RE: Presbyterian Hospital SE Parking Garage

Grading and Drainage Plan Stamp Date: 12/23/19

Hydrology File: K15D005G

Based on the submittal received on 12/30/19, the Grading and Drainage Plan cannot be approved until the following corrections are made:

C-100

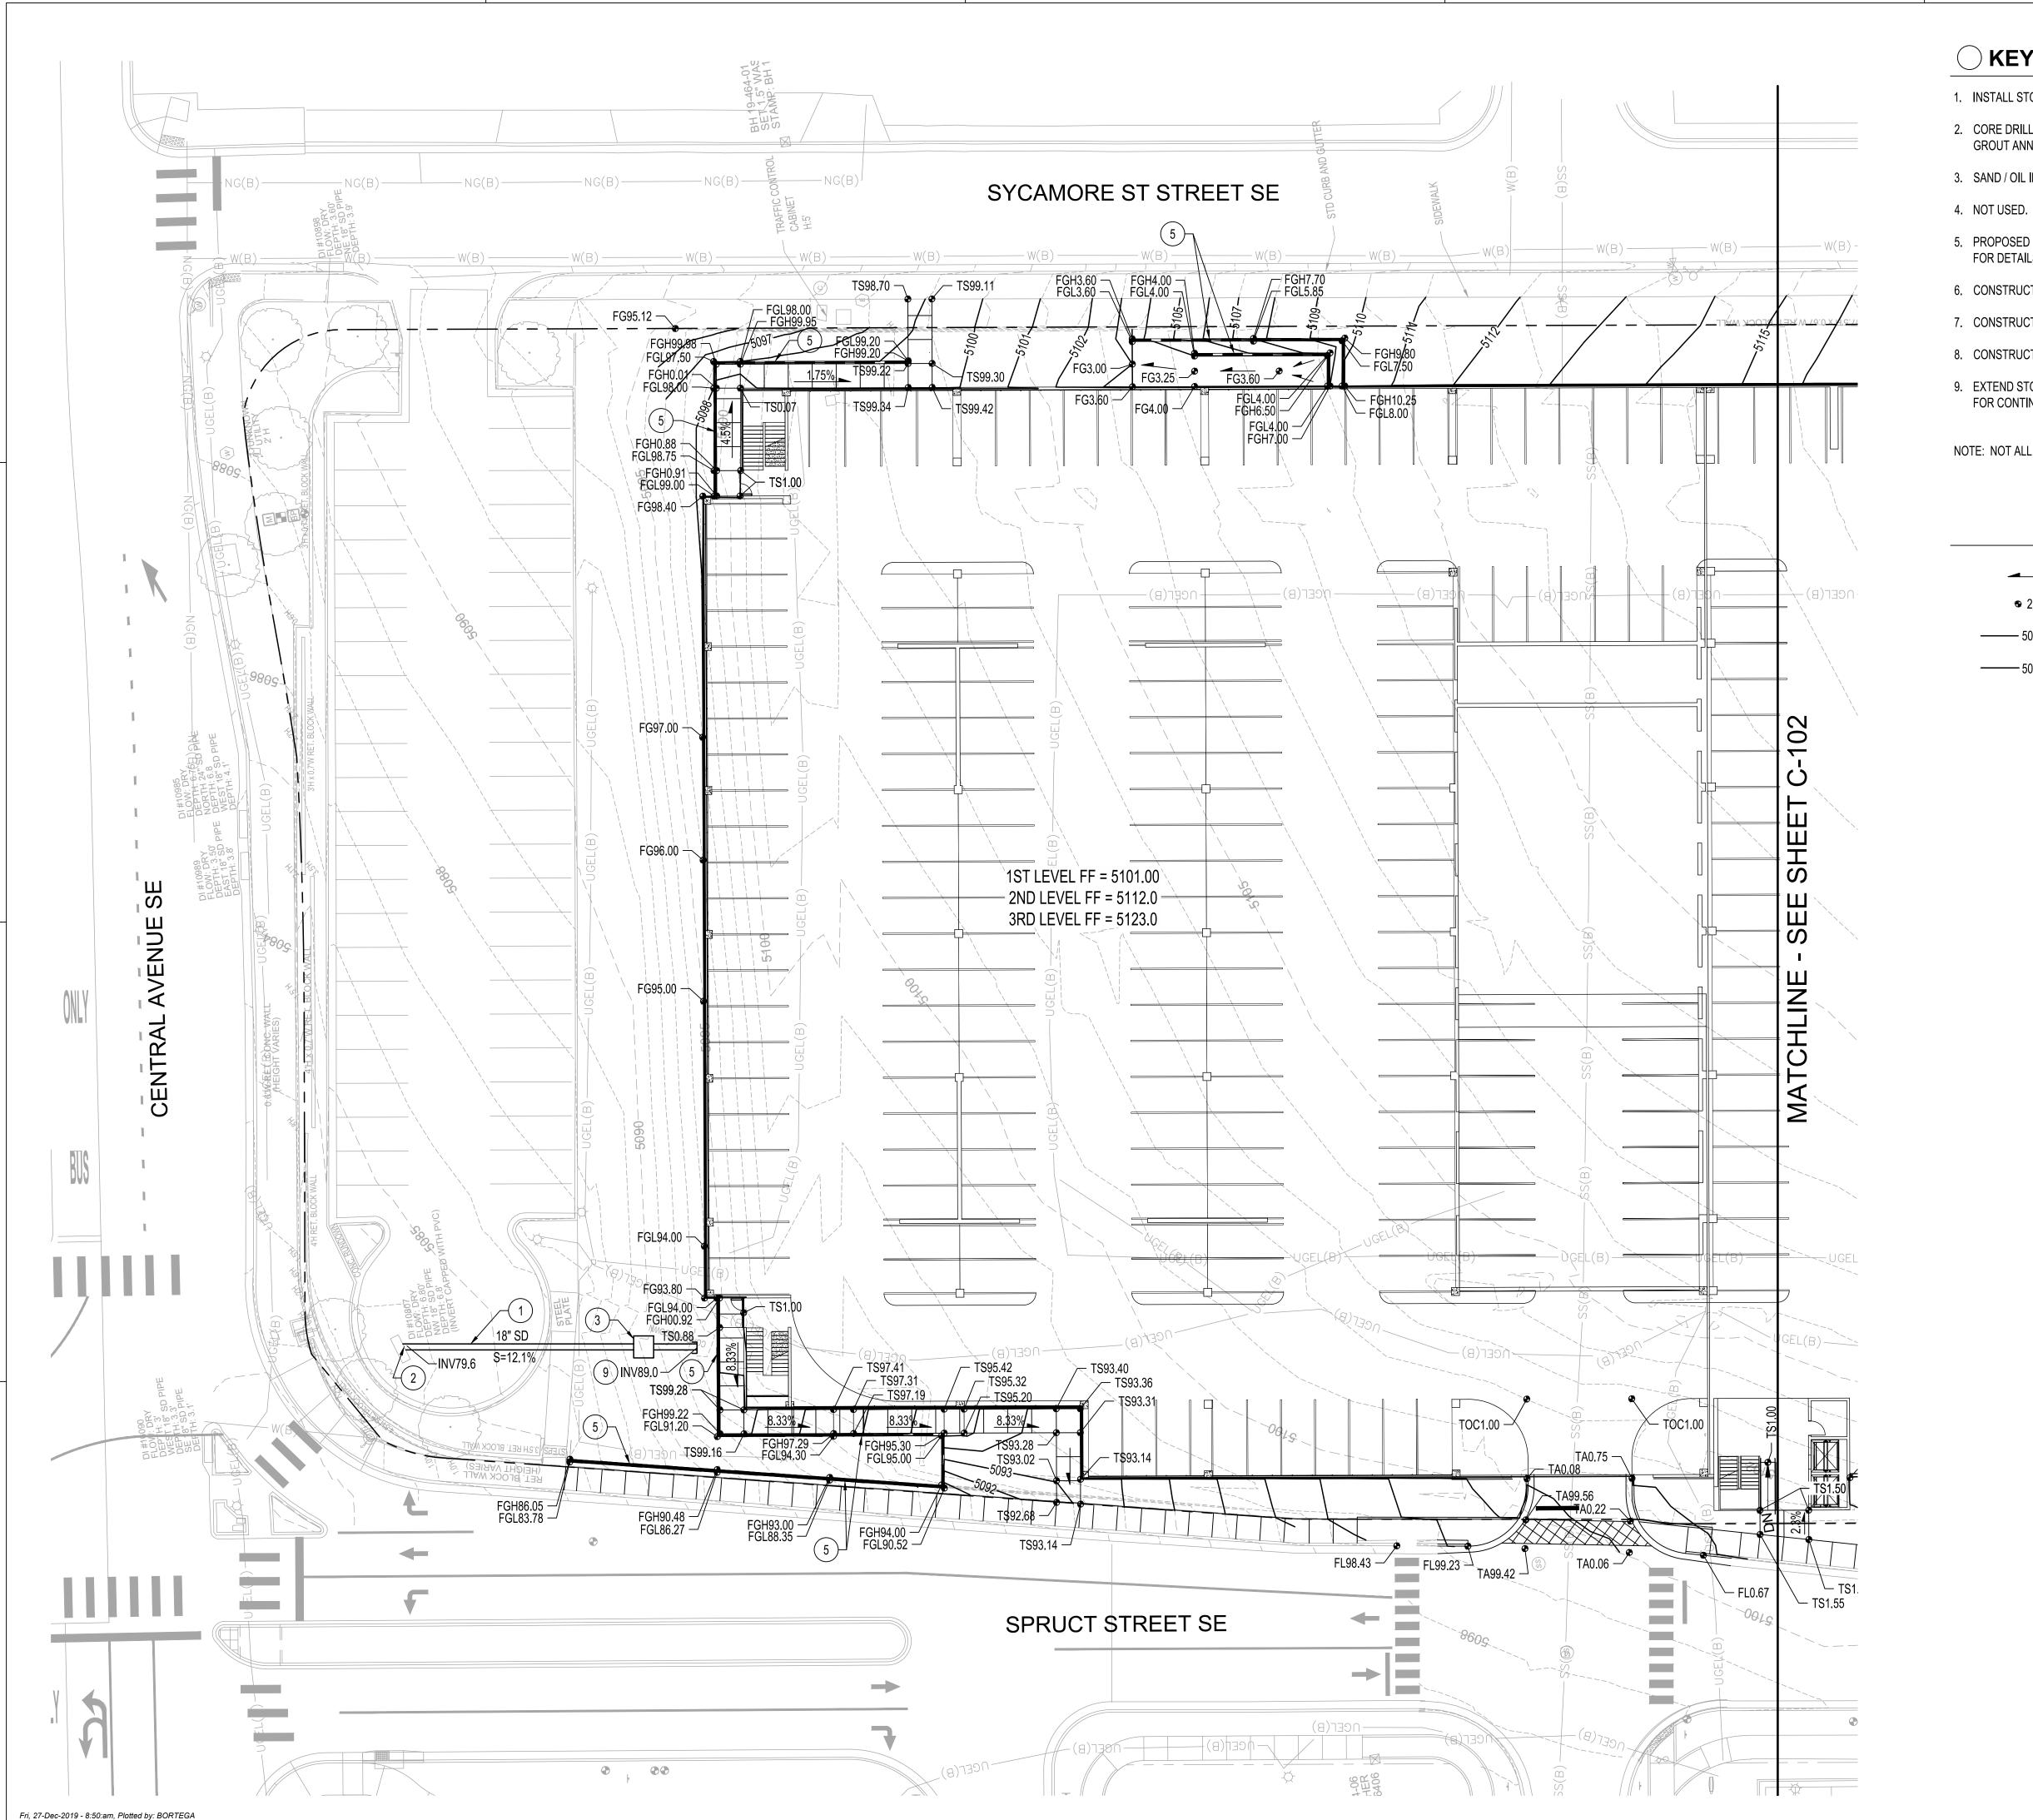
1. The plan must state that: you could provide onsite management, you do not want to (due to cost or convenience), and the owner is electing to make the Payment in Lieu of onsite management.

2. Payment in Lieu (Amount = 3388cf x \$8/cf = \$27,104) of onsite management of the stormwater quality volume (SWQV) must be made. Provide SWQV calculations.

- 3. Flow depth (and EGL) on Silver, in front of the garage entrance, needs to be calculated. Demonstrate that the EGL is less than the proposed waterblock height. Otherwise a standard 0.87' waterblock is required.
- 4. As a reminder, if the project total area of disturbance (including the staging area and any work within the adjacent Right-of-Way) is 1 acre or more, then an Erosion and Sediment Control (ESC) Plan and Owner's certified Notice of Intent (NOI) is required to be submitted to the Stormwater Quality Engineer (Doug Hughes, PE, jhughes@cabq.gov, 924-3420) 14 days prior to any earth disturbance.
